FAWN GROVE AT SUNSET LAKES

an Addition to Wichita, Sedgwick County, Kansas

RE: SUB 2003-120 -- Final Plat of Fawn Grove at Sunset Lakes Addition

STAFF REPORT

FAWN GROVE AT SUNSET LAKES

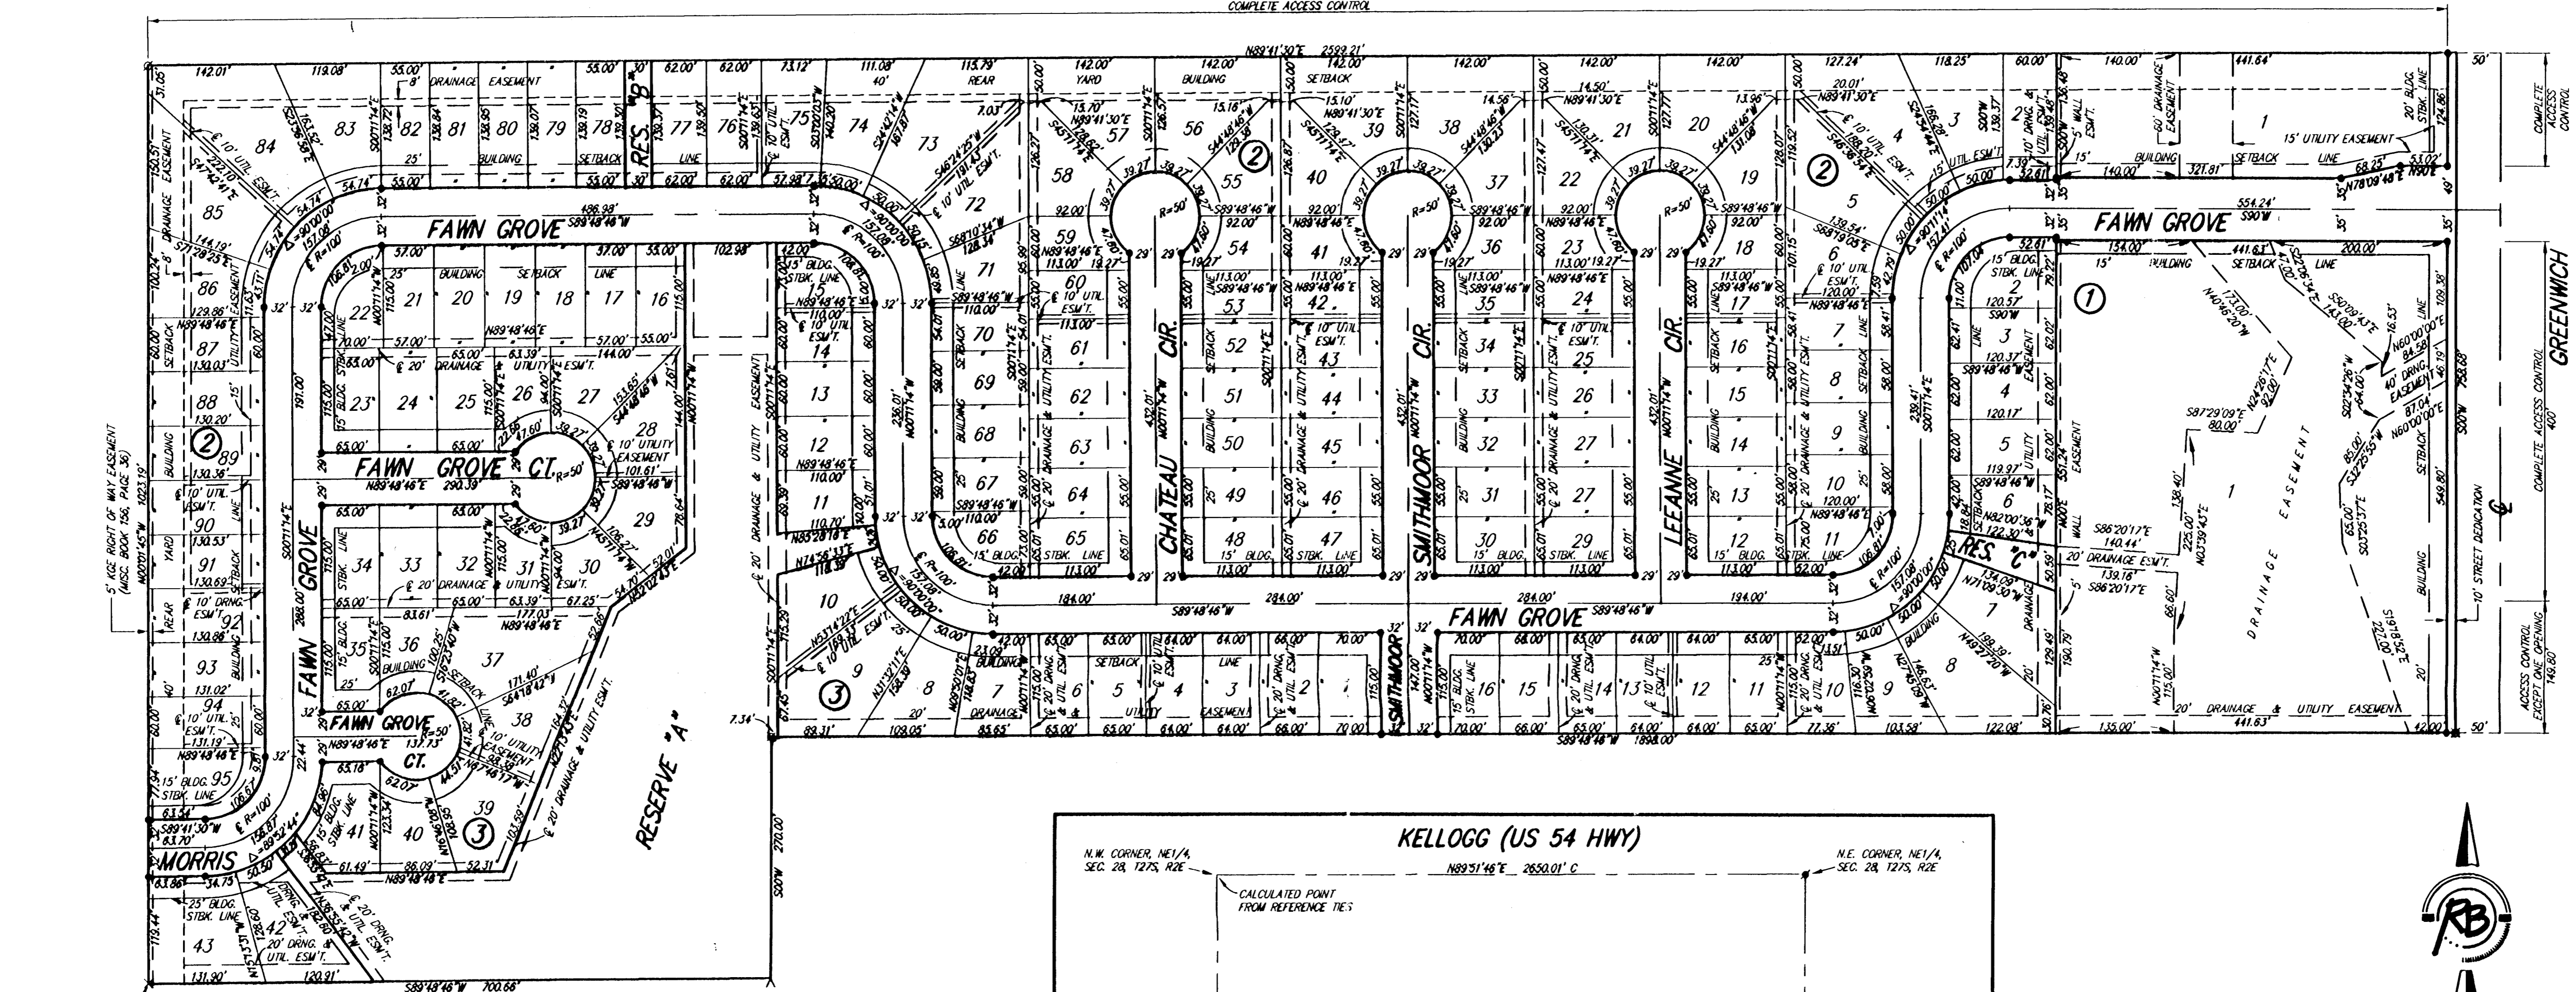
- A. This plat will be subject to approval of the associated zone change and any related conditions of such a change.
- B. The applicant shall guarantee the extension of sanitary sewer and City water to serve the lots being platted.
- C. If improvements are guaranteed by petition, a notarized certificate listing the petitions shall be submitted to the Planning Department for recording.
- D. City/County Engineering needs to comment on the status of the applicant's drainage plan. *Stormwater Management has advised that the drainage plan must be in compliance with the drainage study currently being prepared for this area.*
- E. The plat proposes one access opening along Greenwich. *Access controls are approved.*
- F. A 70-foot right-of-way for a commercial street is needed along Fawn Grove from Greenwich to the west line of Lot 1, Block 1 tapering to a 64-ft right-of-way.

- G. Traffic Engineering has requested the right-of-way width be increased to 64 feet for the street stub to the south.

- I. It is recommended that Reserve A be extended to the street by access easements or by narrow strips of Reserve between the lots to increase its accessibility and usefulness for all homeowners in the Addition.

- M. Block 1 west of Smithmoor should be labeled as Block 3.
- N. Traffic Engineering has requested a petition for left turn lanes.
- O. Morris does not line up with Morris as platted in Harrison Park 2nd Addition by 1.48 feet.

- Z. The representatives from the utility companies should be prepared to comment on the need for any additional utility easements to be platted on this property. Westar Energy has requested additional easements.

The right-of-way has been platted as requested.

The right-of-way width has been platted as requested.

The Applicant has provided an additional connection from the street to the Reserve as requested.
